City of Biddeford
Planning Board
December 20, 2023 6:00 PM City Hall
Council Chambers, & Zoom
<https://biddeford.zoom.us/j/94983531202?pwd=Q3ZyejcyUVpBaUVVMHduYXJhSzB4UT09>
Webinar ID 949 8353 1202; Passcode 223739

Case 2023.44: Preliminary Site Plan Review for Everybody Loves Raymond St, LP / Proposed Construction of a 10-unit residential structure on Raymond Street (Tax Map 29, Lot 108).
Planning Board Hearing date: December 20, 2023.

Per your request Site Design Associates has undertaken a review of the plans and documentation submitted in support of a site plan application for the referenced project. Our review was based on preliminary civil engineering plans dated 11-22-23.

PROJECT: BERRY PARK EXPANSION 27-81 RAYMOND STREET, BIDDEFORD, ME	SHEET TITLE: EROSION CONTROL NOTES & DETAILS	CLIENT: EVERYBODY LOVES RAYMOND ST, LP 17 SOUTH STREET, 3RD FLOOR PORTLAND, ME 04101
DATE: 8/23/2023	SCALE: AS NOTED	JOB NO: 20-68
SHEET: C-6.0

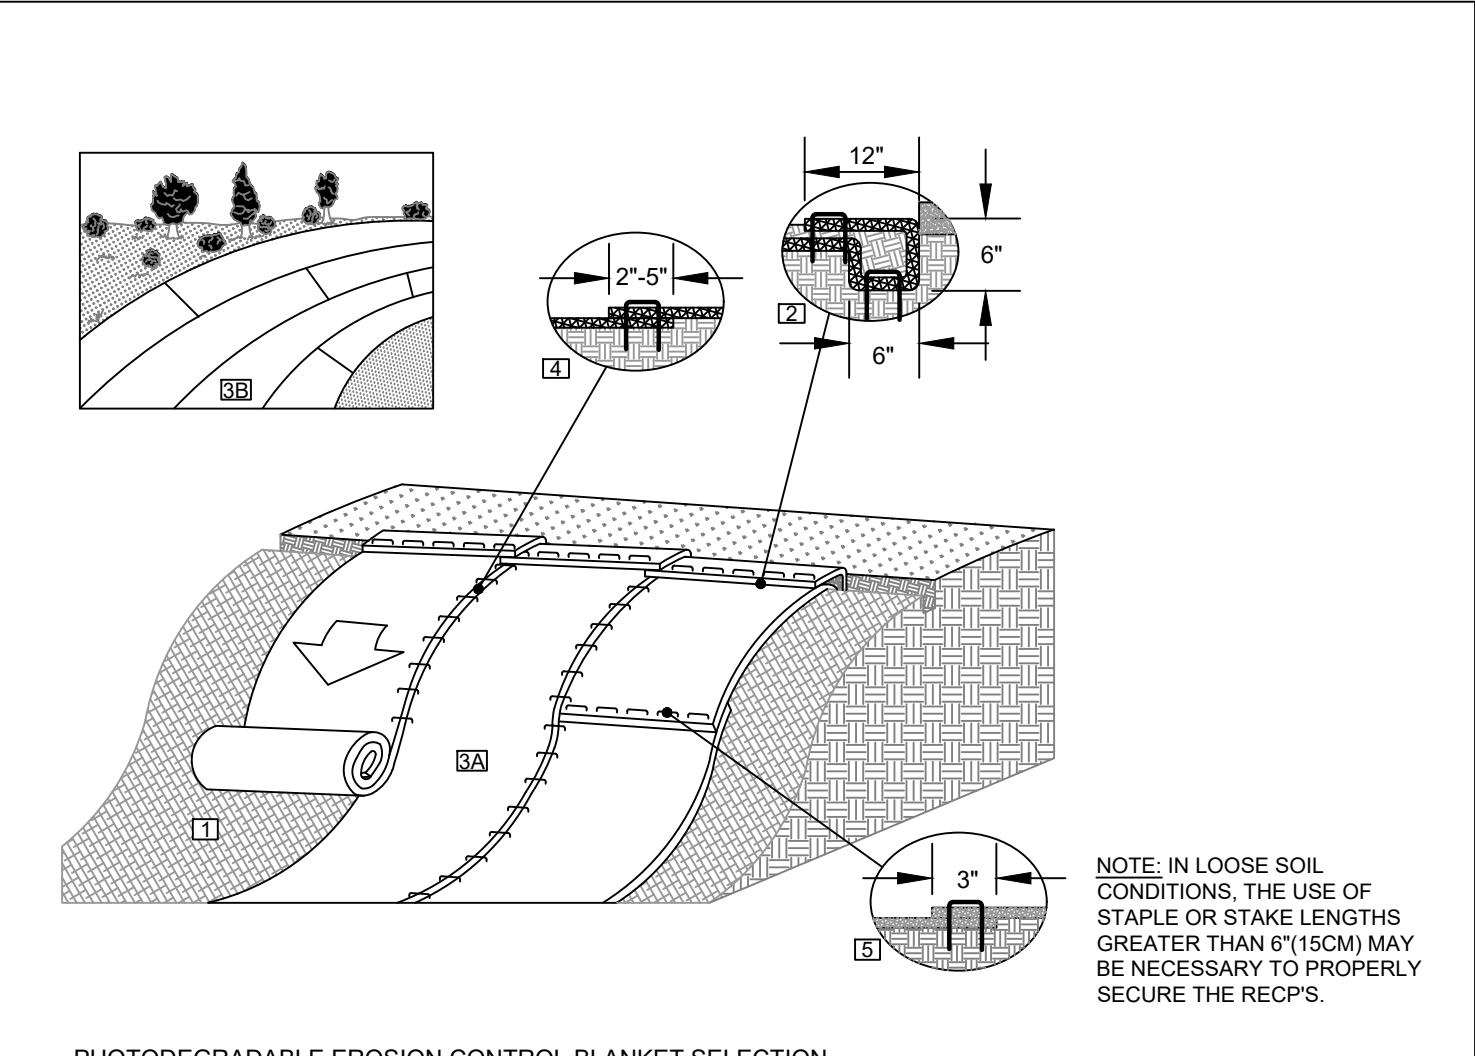
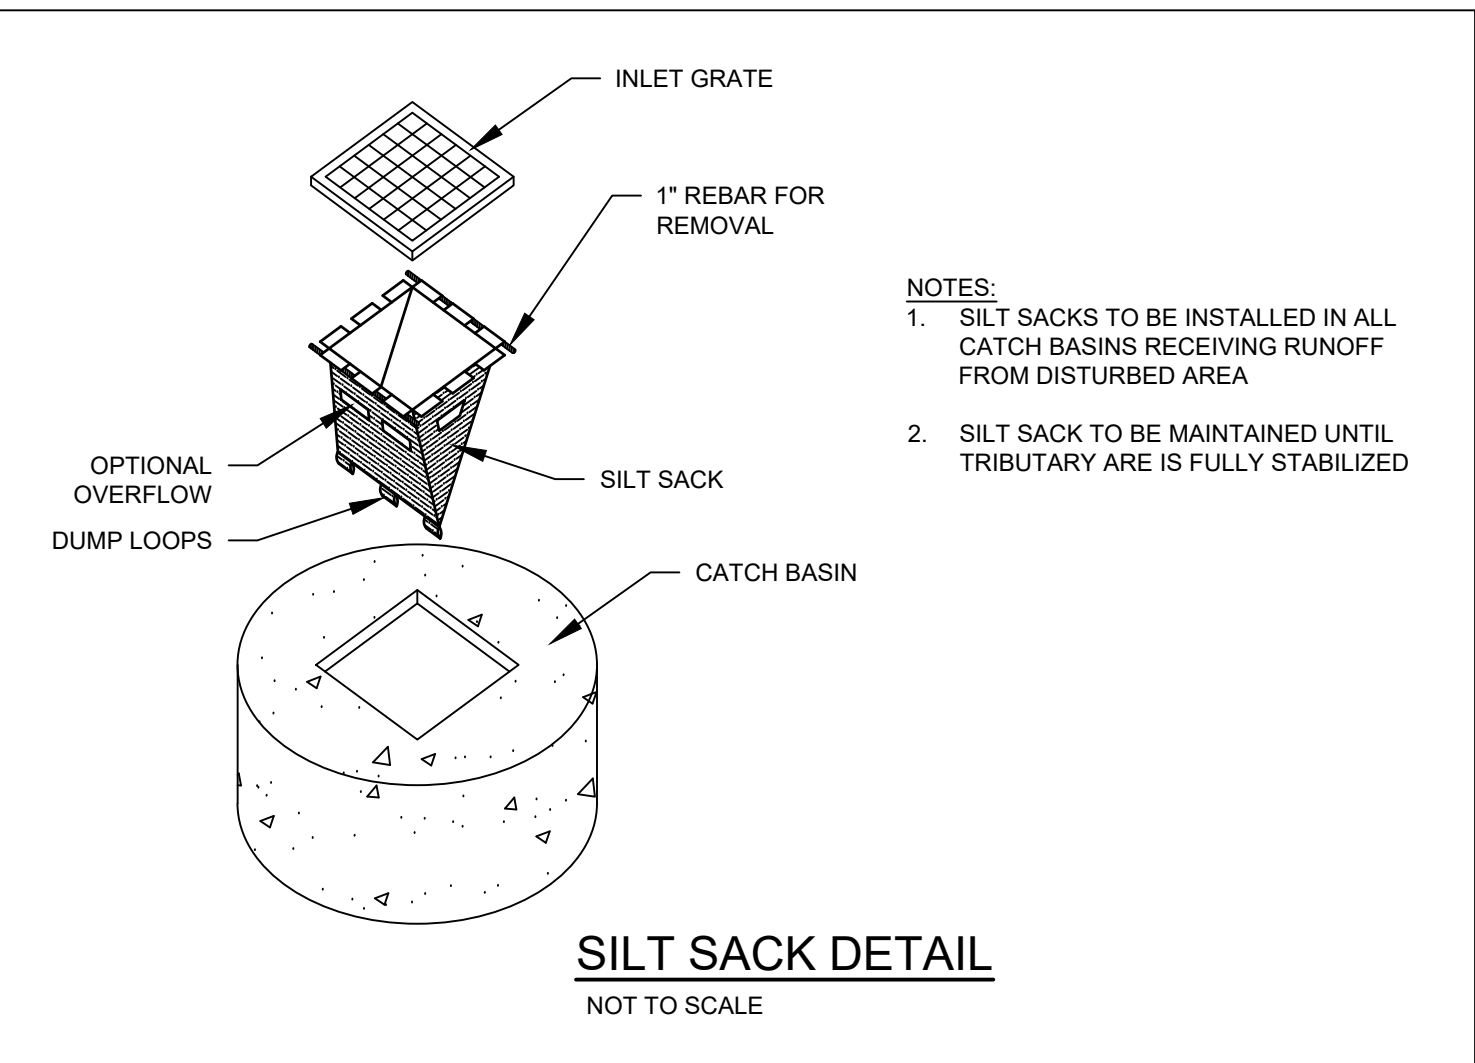
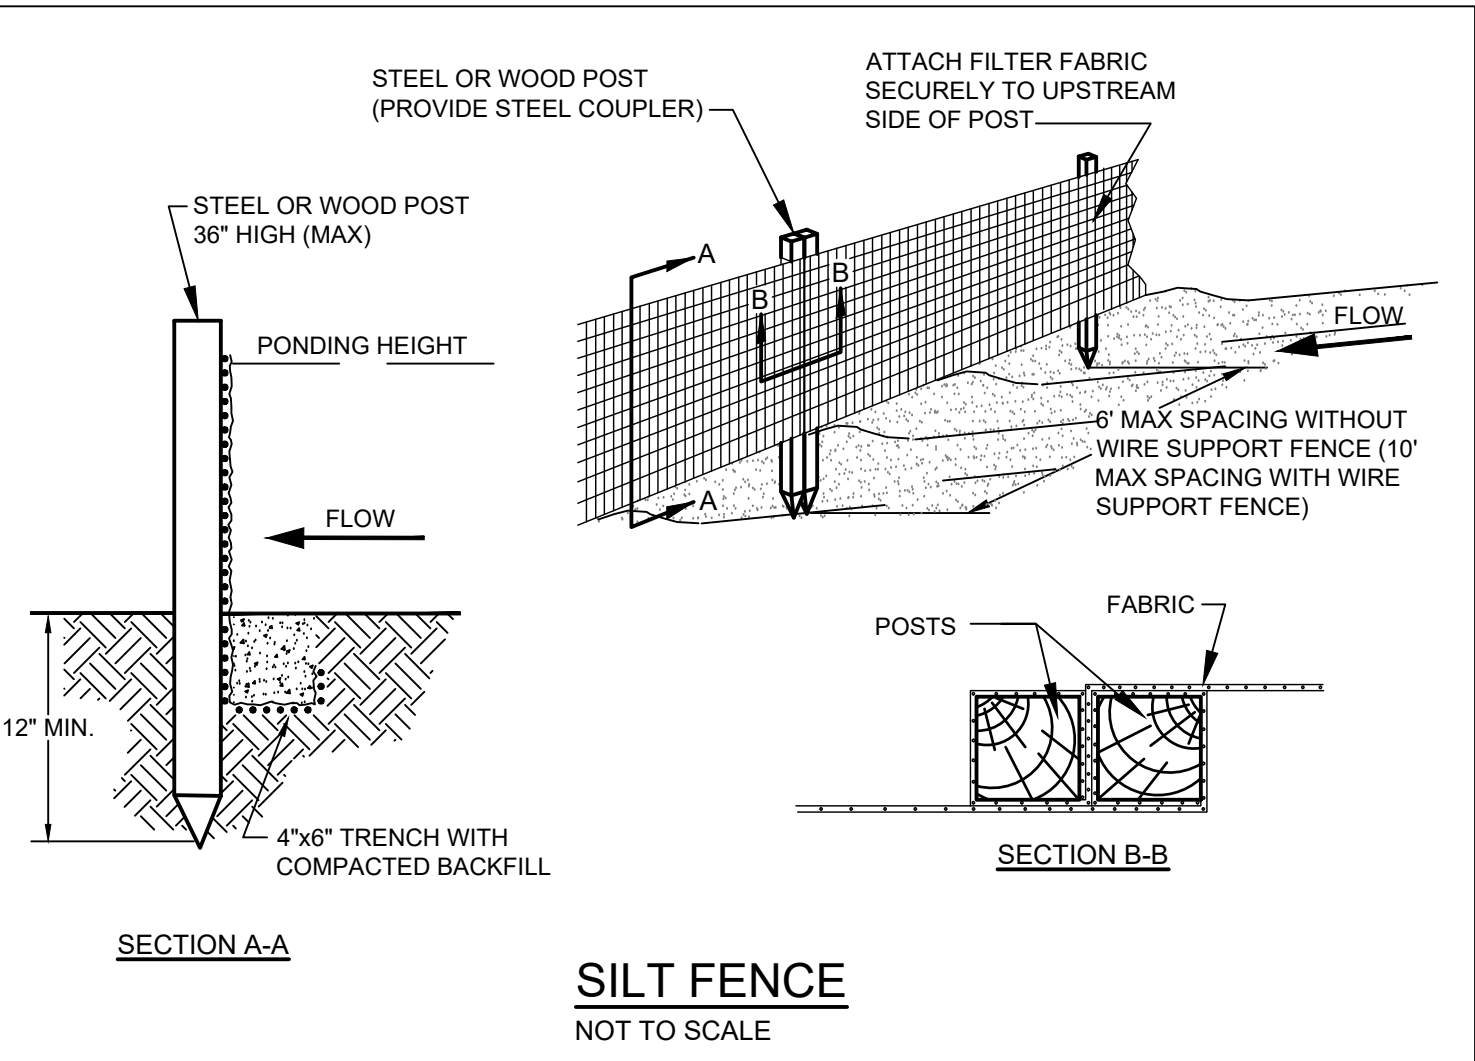
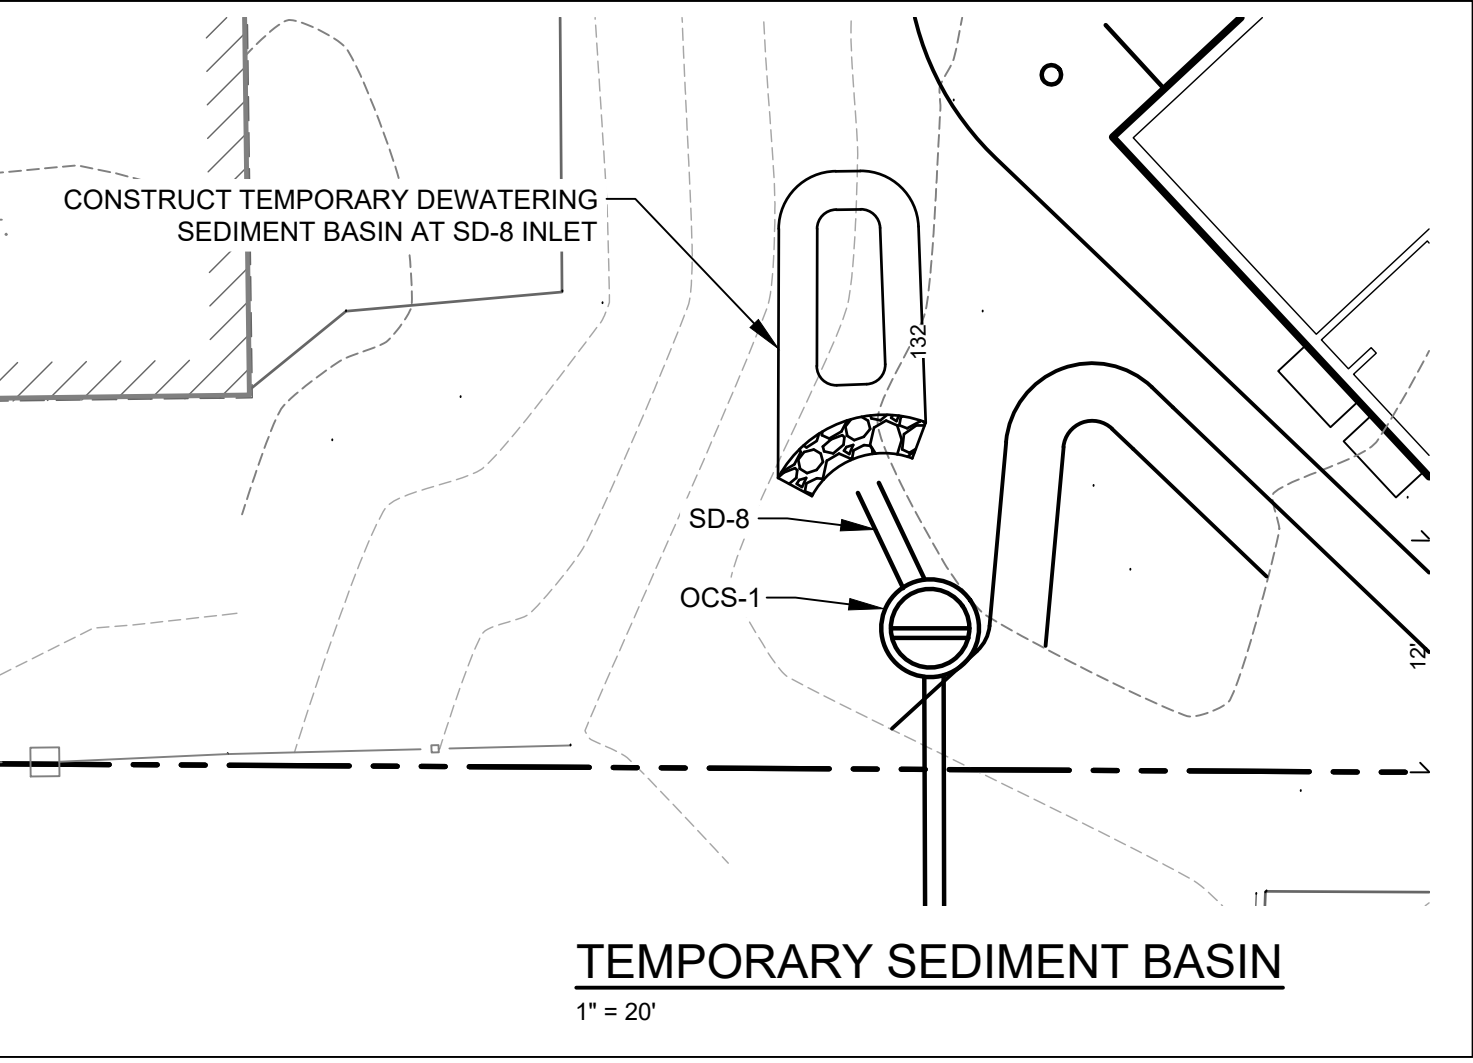
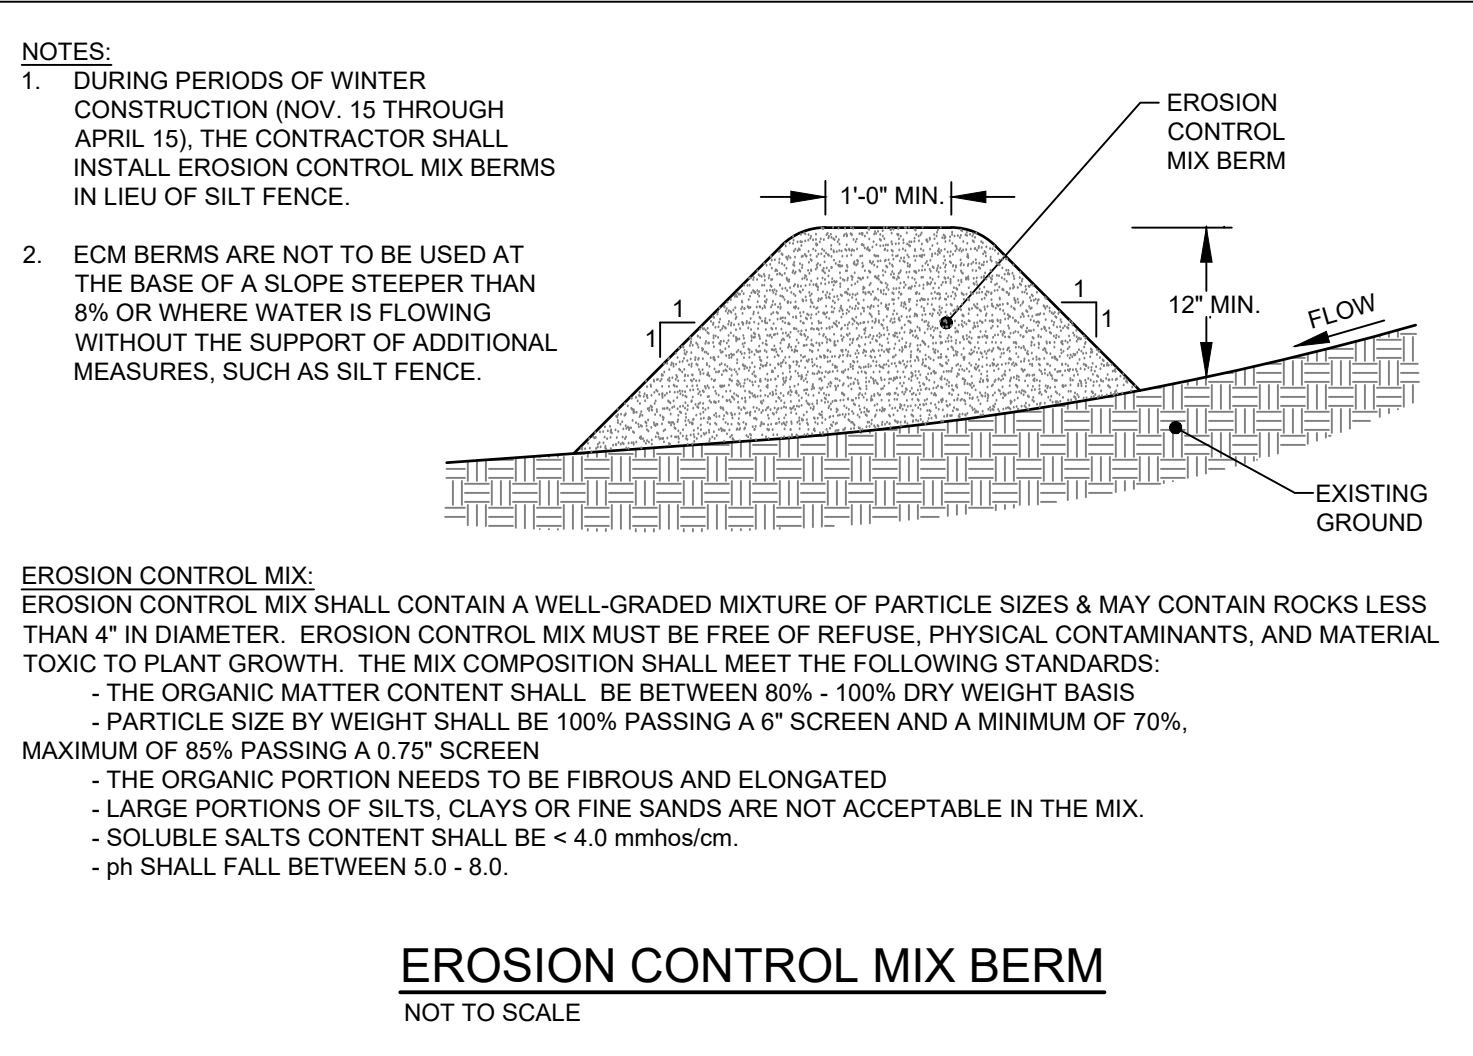
- a. Requirements for inspections during construction outlined in Chapter 500, Appendix B.1. should be included on Drawing C-6.0 and should be consistent with the requirements of the MDEP stormwater checklist.

- b. It is not clear the 7 ft x 12 ft x 1 ft deep sediment basin will be effective in providing sediment migration from the site. How was this sized?
- c. Rather than calling for the saw cut and removal of surface pavement on the pavement joint detail, the outside 1 ft should be milled to the depth of the surface course. The sawcut through the entire existing pavement section would occur 1 ft from the milled section.
